***Concern:***

Independent CASA Grande runs generated results that appear to be inconsistent with the February 4 STP presentation in two areas: (i) the critical fiber (LDFG fines) threshold of 191.78 lb, used to determine whether the amount of LDFG fines on the strainer is within the tested range of conditions; and (ii) the number of welds that could generate fines in exceedance of the critical threshold.

Figure 4: LDFG Fiber versus break size. The intersection of the fiber versus break size curves with the dotted lines is used to estimate the exceedance break.

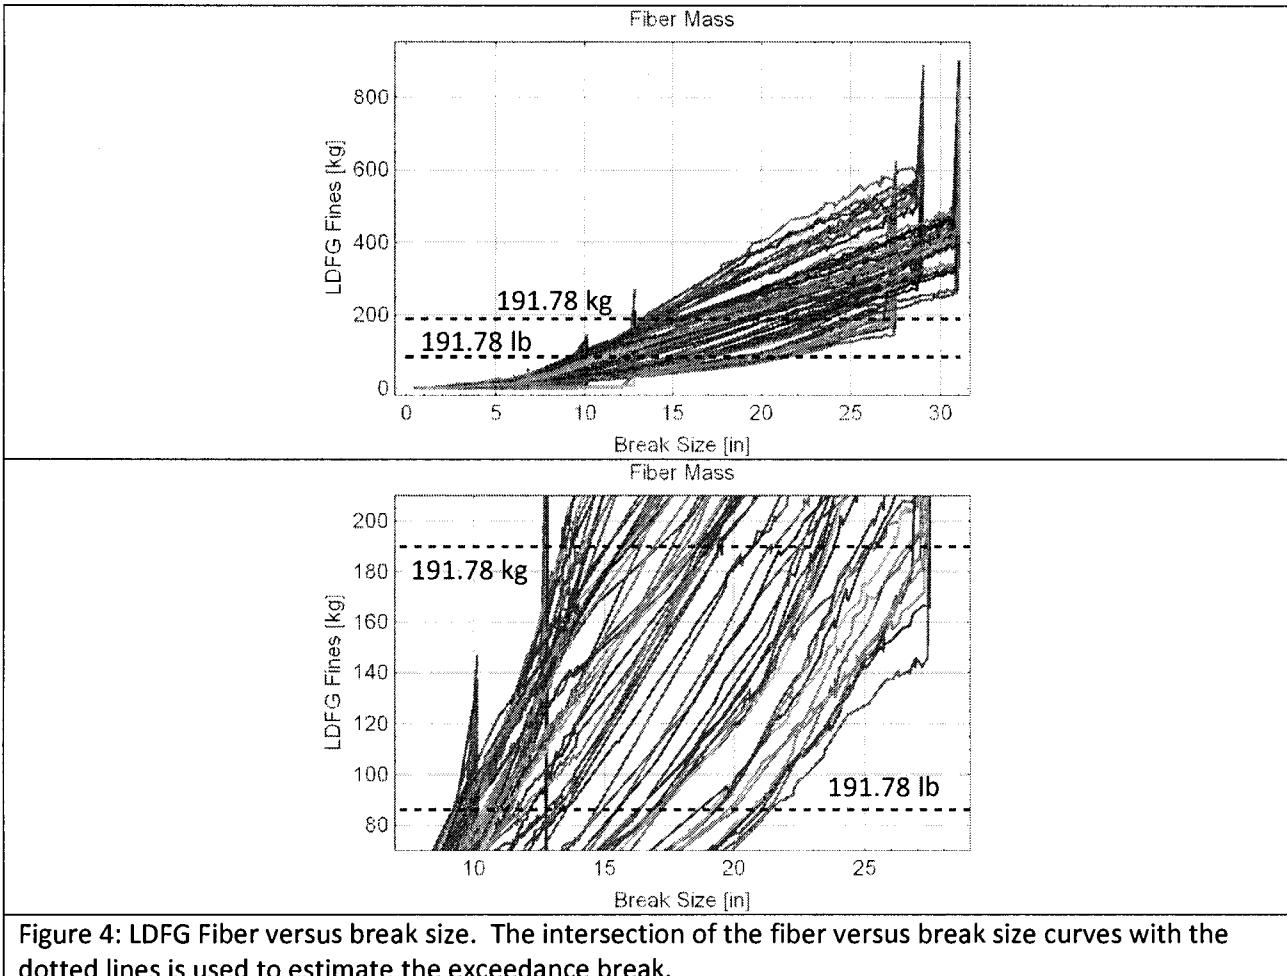
The following analysis identifies weld locations that can yield LDFB fines in excess of 191.78 lb (=87 kg) and in excess of 191.78 kg. The higher limit results in values and weld locations that are consistent with the tabulated data in Slides 17-19 of the February 4 presentation. Therefore, we suggest that there may be a kg to lb conversion error either in the CASA Grande or in the results presented at the February 4 meeting.

Figure 4 superimposes the 191.78 lb and 191.78 kg thresholds on the curves of LDFG fines versus break size from Figure 2. The exceedance breaks are computed, by interpolation, by determining the point at which the LDFG fines mass versus break size crosses the dotted lines, for each weld location. Table 1 shows the 191.78 lb exceedance breaks (i.e. the break at which the produced LDFG fines would exceed 191.78 lb). A total of 109 weld locations were identified that could exceed 191.78 lb of LDFG fines. Each of the 45 exceedance breaks reported in Slides 17-19 of the February 4 presentation is larger than the interpolated break size for the same weld (ranging from 9.2 in to 21.5 in) using a threshold of 191.78 lb.

In the independent computations, a total of 68 weld locations were identified that could exceed the 191.78 lb threshold. Why did STP identify fewer locations (i.e., 45 locations)?

Figure 5. Exceedance break independently computed versus the exceedance break reported in Slides 17-19 of the February 4 presentation, for 45 weld locations. Values exactly falling on the dotted line indicate identical results in both methods.

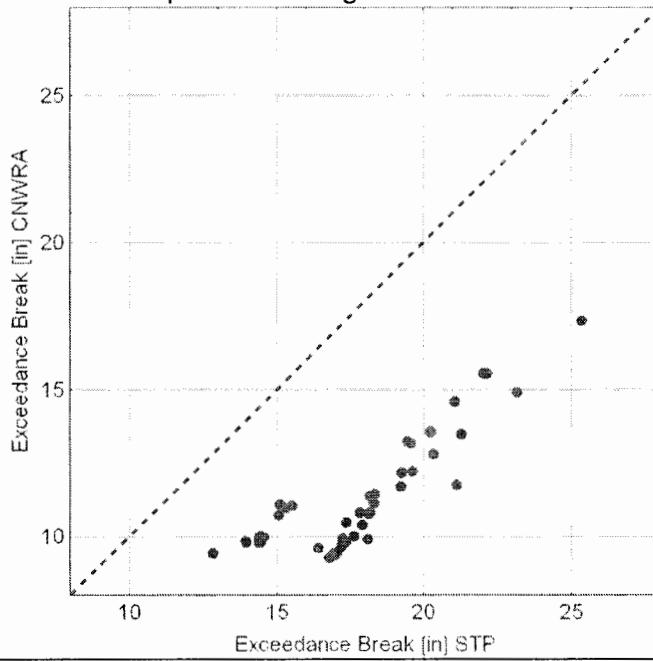
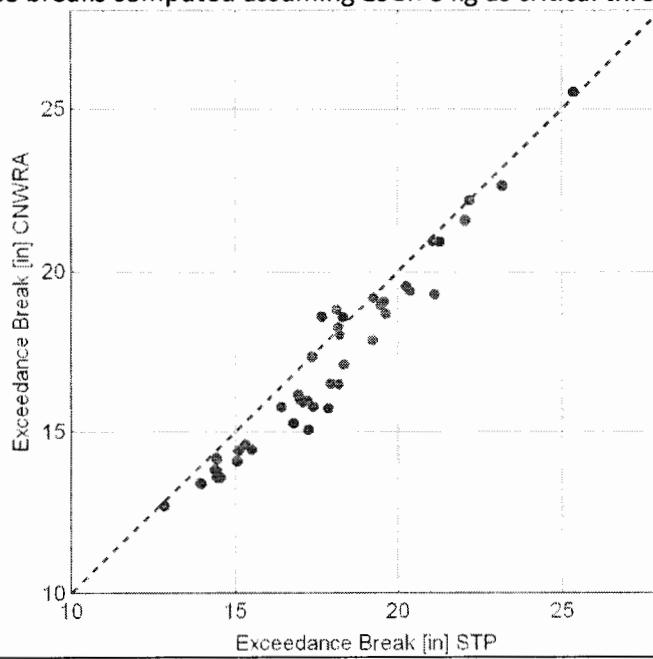
Table 2 lists the weld locations and break sizes that the independent analysis suggests could exceed 191.78 kg of LDFG fines. All of the 45 weld locations in Slides 17-19 of the February 4 presentation are included in this list, and the magnitude of the exceedance break is in agreement with the STP values. Figure 5 is included to demonstrate that the agreement of the two sets of results (the STP results and our independent results) is reasonable when the critical limit is assumed to be 191.78 kg. Figure 5(A) shows the exceedance breaks assuming a threshold limit of 191.78 lb versus exceedance breaks in Slides 17-19 (data from Table 1). Figure 5(B) displays the exceedance breaks assuming a threshold limit of 191.78 kg versus exceedance breaks in Slides 17-19 (data from Table 2). Figure 5 indicates that data in Table 2 is in better agreement with the STP values in Slides 17-19. Differences in the results are expected because only a limited number of CASA Grande realizations were executed in our independent analyses. However, the results are in such a reasonable agreement, that it is warranted to request STP to check whether it used 191.78 kg as threshold value in its computations, instead of 191.78 lb.
